# SITE CONSTRUCTION PLANS FOR MARCO GOLF AND GARDEN MARCO ISLAND - COLLIER COUNTY, FLORIDA

*Approved Set  
 Joseph D. L.  
 12/10/2012*

BDP No. 12-02  
 Approved by: Joseph D. L.  
 Date: 12-10-2012

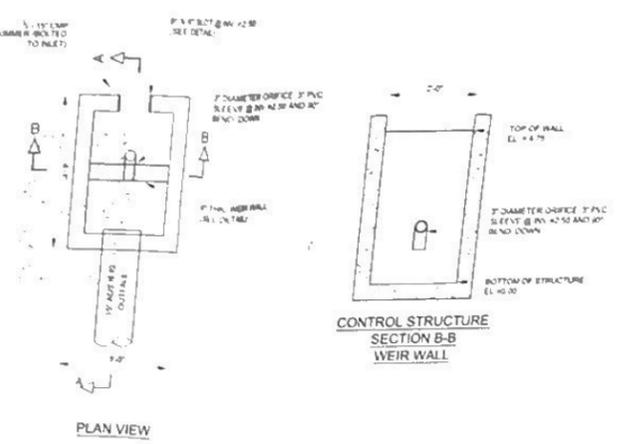
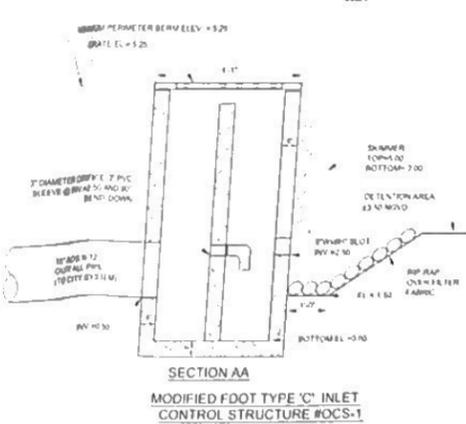
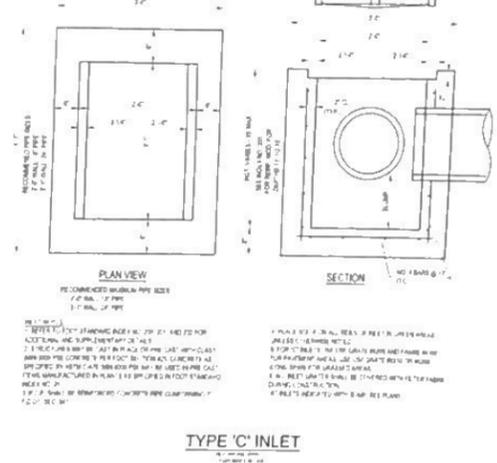
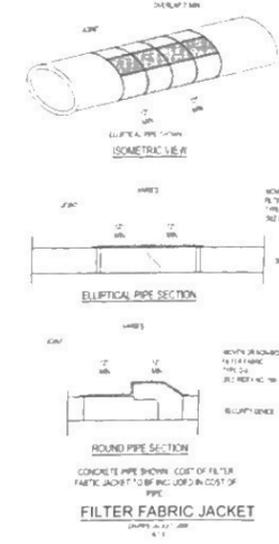
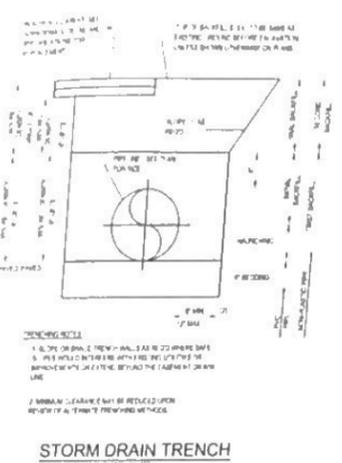
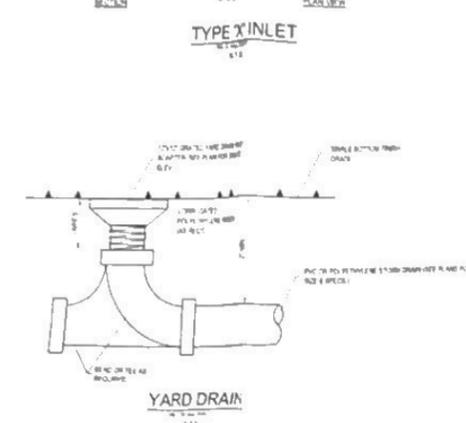
See comment  
on sheet 5 of 11.  
Joseph R. [Signature]  
12/10/12

HERBERT ROSSER SAVAGE, AIA, ARCHITECT 851 50 COLLIER BLVD MARCO ISLAND, 34145 - PH (239) 394-1580		DATE: SEPT 12, 2012 SCALE: NOTED
PROJECT: MARCO GOLF AND GARDEN 961 Winterberry Drive Marco Island, FL 34145	SHEET TITLE: ELECTRICAL SITE LIGHTING	SHEET NO: ES-1 OF ES-1

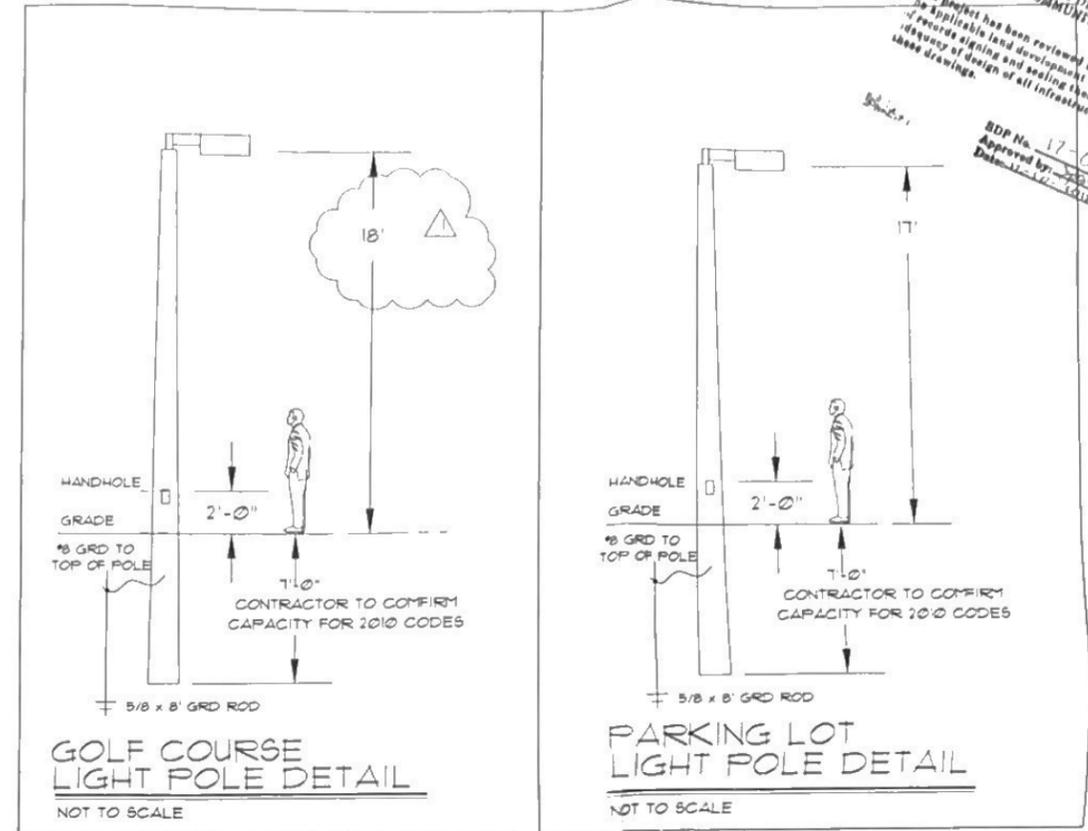
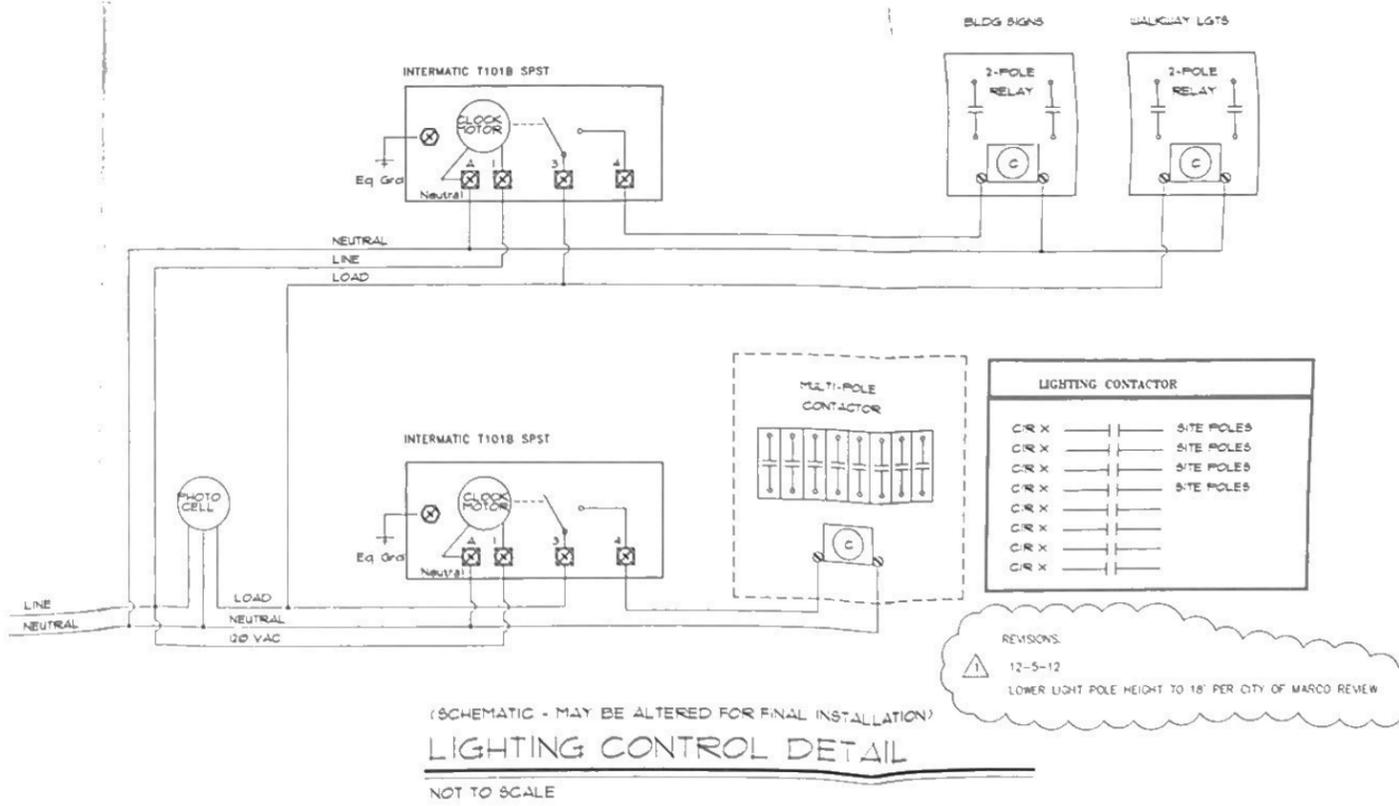
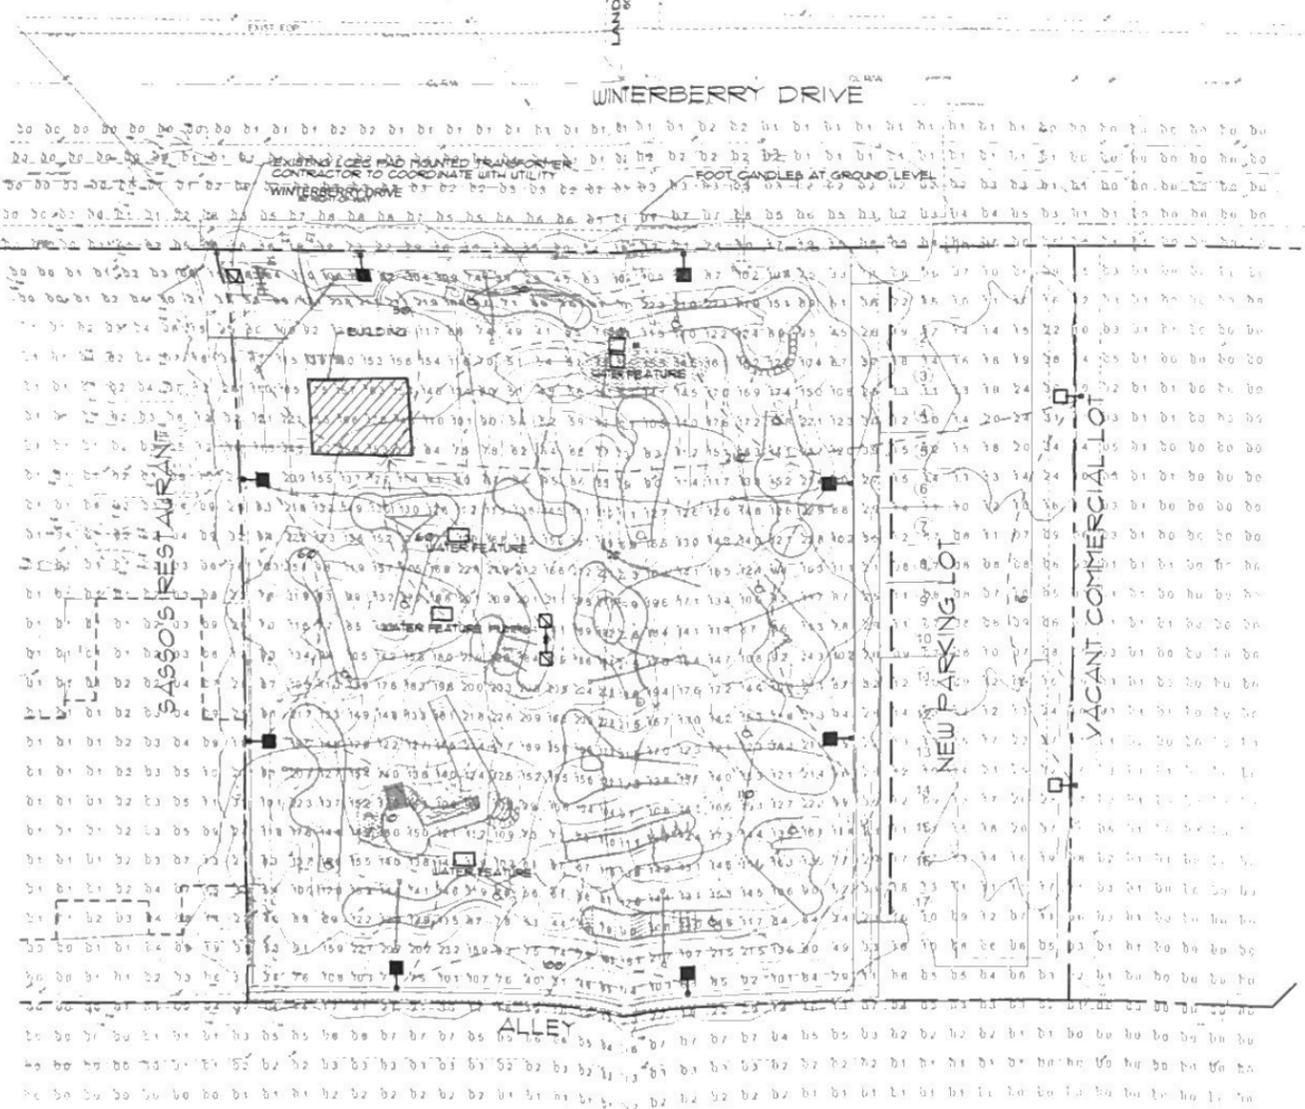
REVISIONS  
12-5-12  
LOWER LIGHT POLE HEIGHT TO 18' PER CITY OF MARCO REVIEW

FIXTURE MOUNTING HEIGHT -  
750W POLE MOUNTED 18' AFG  
150W POLE MOUNTED 17' AFG  
SOLINES AT 1 FC  
POLES BY OTHERS
